Re: Response to the June 7, 2024 LVPC review letter of the Easton Commerce Park project.

On June 7, 2024, Lehigh Valley Planning Commission (LVPC) released a review letter of the project. It contained a detailed analysis of the project in relation to LVPC planning standards and the LVPC Comprehensive Plan, titled *FutureLV: The Regional Plan*. What follows is a response to the items noted in the review letter following the same subject outline as the letter provided:

The red line shows the proposed trail connection.

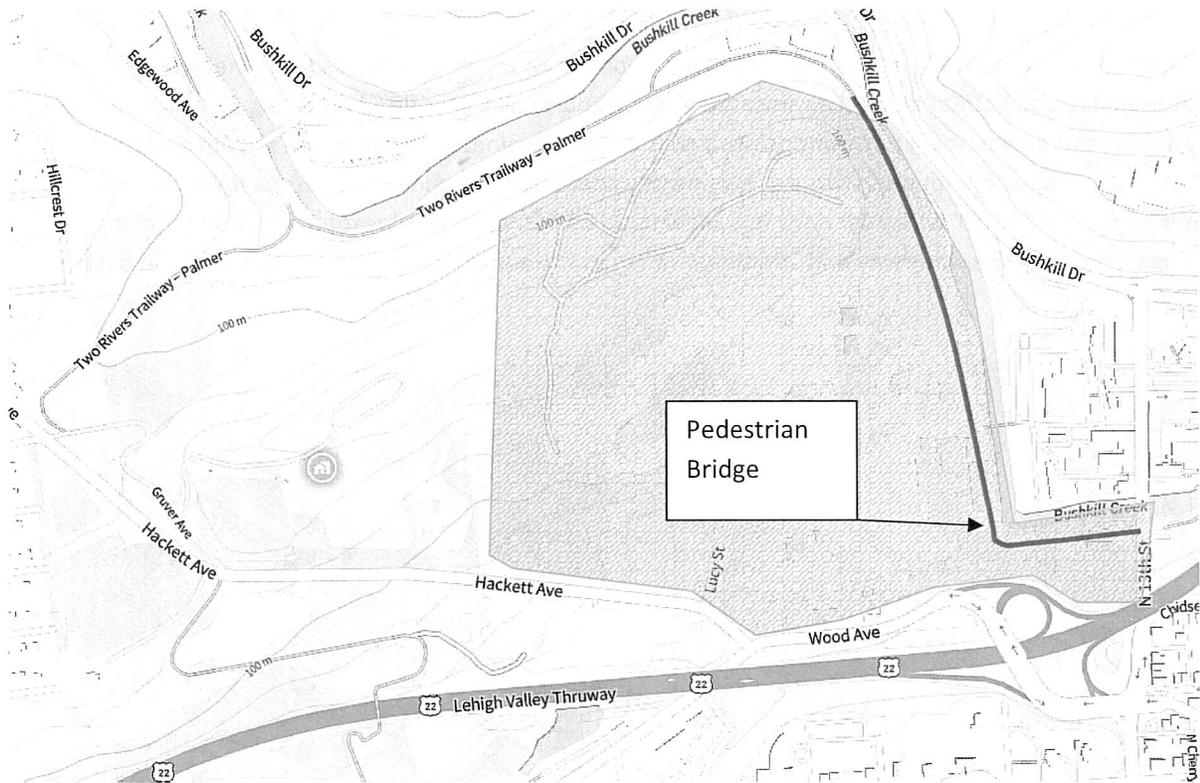
“Preserve natural, recreation, cultural, historical and scenic assets” – this was evaluated and accomplished by extending a multi-use trail connection to link up two disparate trail sections within the region, allowing for greater recreational opportunities to the area residents; by shifting the site design to leave the greatest connected areas for the existing woodlands and not fracturing it; and by reconnecting the tributary to the Bushkill Creek in a manner to enhance fish passage, habitat, and other biological uplift.

A cross-section view of the stream bed and wetland bench that is designed to receive water from a typical 2-yr storm event.

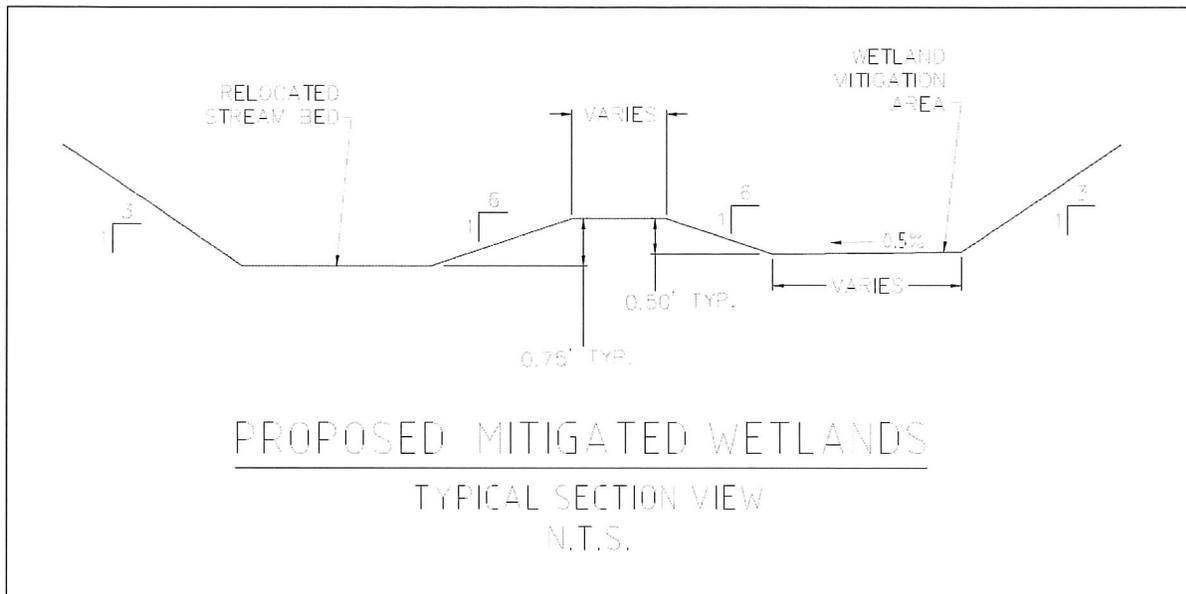
The review letter noted that the existing floodplain for the tributary stream to the Bushkill Creek is subject to DEP and FEMA review. This review is already in process and also includes the Army Corps of Engineers since it qualifies as a Joint Permit under DEP regulations and is not a General Permit. This process is well underway with DEP providing an Administratively Complete determination on the application and letter of Technical Comments to address. There were only four technical comments needed to be addressed for DEP to approve the Joint Permit application and the applicant team has already discussed the specific nature of the comments with DEP’s review team to ensure a smooth completion on those items.

The relocated tributary is a major beneficial uplift to the existing conditions on the site. The stream will be relocated away from areas noted as contaminant hot-spots under the EPA Act 2 clean up that is ongoing for the project site. It will also daylight the stream which is underground for greater than 300’ and remove obstructions that restrict fish passage from Bushkill Creek up into the tributary. These uplift activities are a vital improvement to the natural trout stream watershed and will allow the habitat connection that was previously cut-off with the stream being located underground.

The above shows the stream relocation with landscaping and wetland pockets (light blue areas) that act as flood banks along the stream.

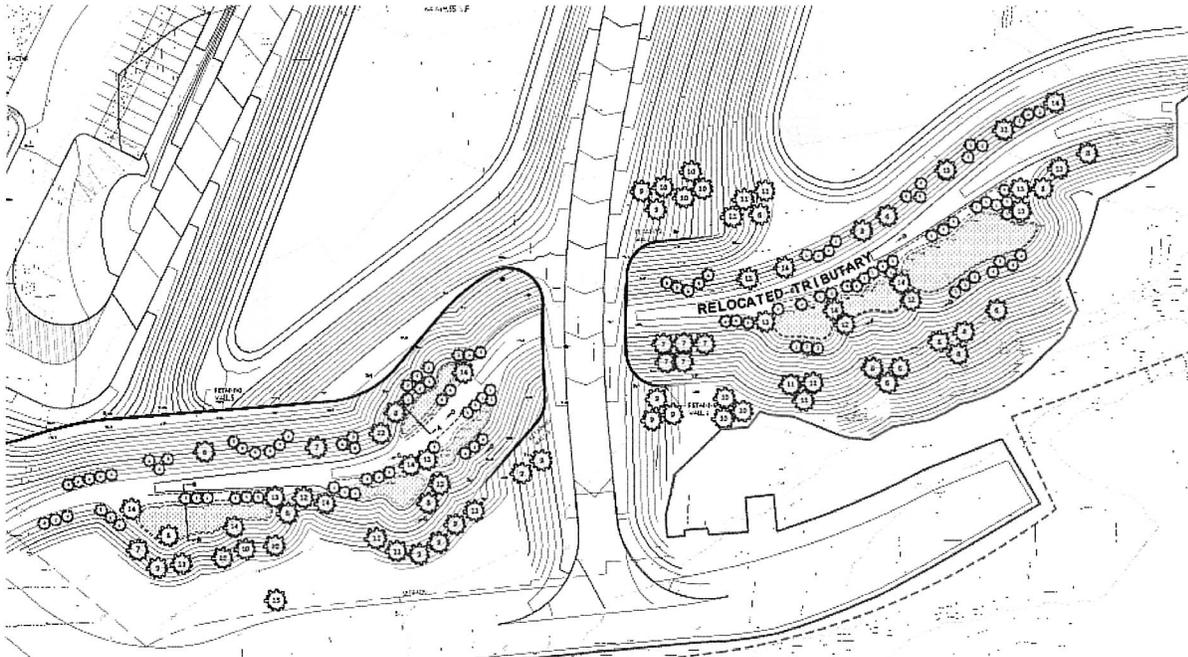
The landscaping portion of the response below includes planting schedules and diagrams for the riparian buffers and wetlands landscaping plan.

Aerial showing the parking lot and path to the previous industrial development. The blue arrow points to the previous path, the red arrow to the pedestrian crossing sign, and the yellow arrow to the

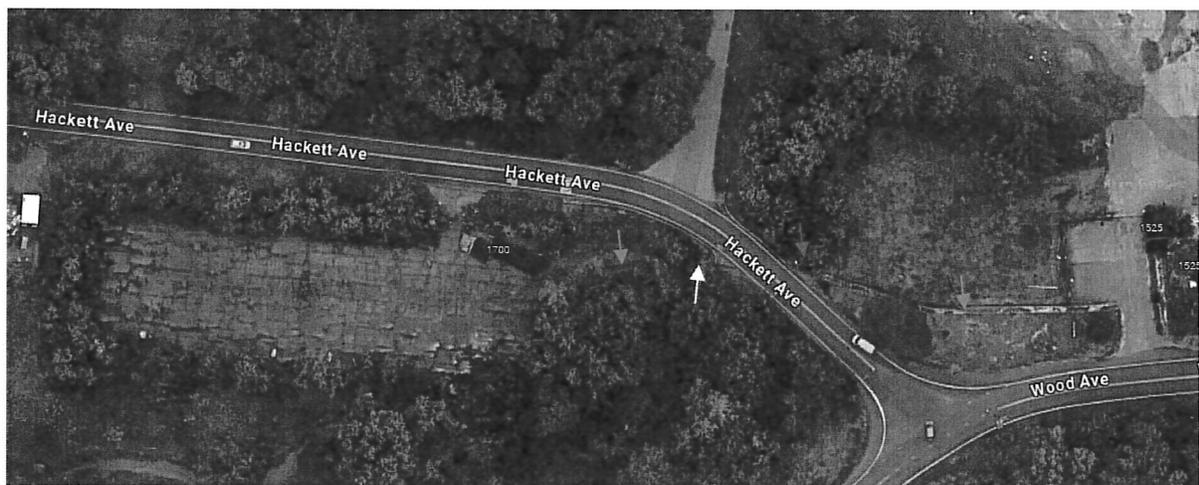
In the LVPC letter, they included a picture of a pedestrian crossing sign located near the intersection of Hackett Ave. and Wood Ave. The subject property is split by Hackett Ave and a portion, which includes a no longer used parking lot, was on the south side of Hackett with a pedestrian bridge over the tributary there, and was a connection from the previous industrial development on the site to the parking lot. This sign appears to no longer be applicable crossing from the property on the south side to the north side as there is no intention of using the south side portion of property and the pedestrian bridge over the tributary has since been removed.

The red dashed line shows the path from 13th Street to the building.

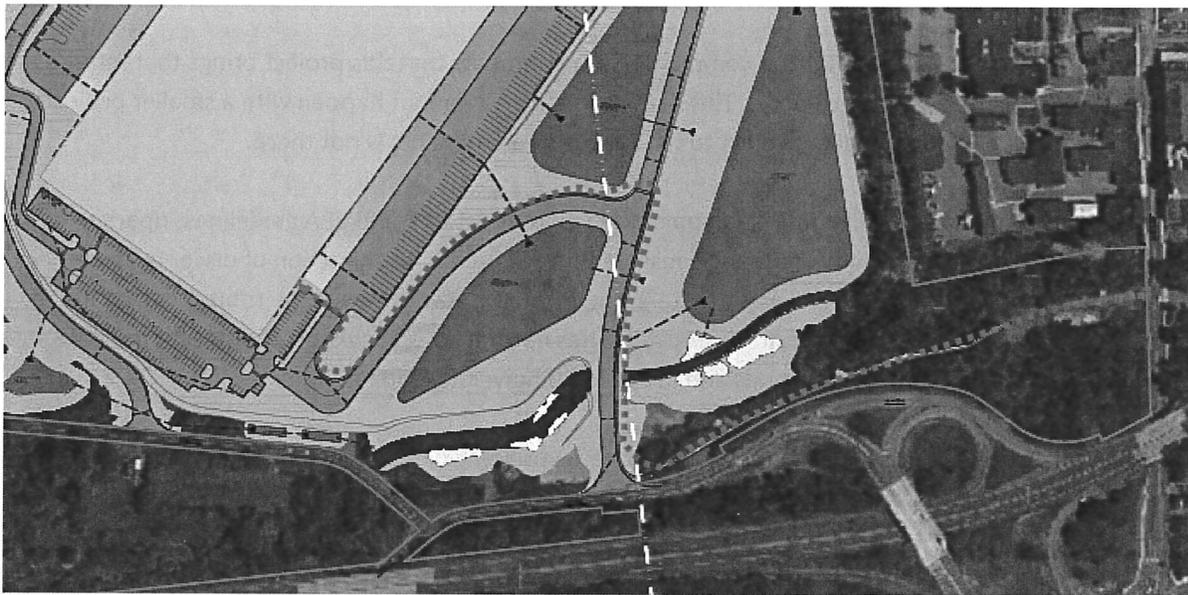
Based on LVPC's letter and recommendations, an additional trail connection from 13th Street to the site access driveway and then further to the building are integrated into the latest plans provided to the City for the review process. The developer would like to encourage the addition of a bus stop at 13th Street where the project's eastern most property extends to allow for access to the trail and the proposed development. This would be in-line with Policies 2, 4, and 5 that encourage multi-modal transportation, a connected mixed-transportation region, outdoor recreation and open space access, and healthy, inclusive, and livable communities.
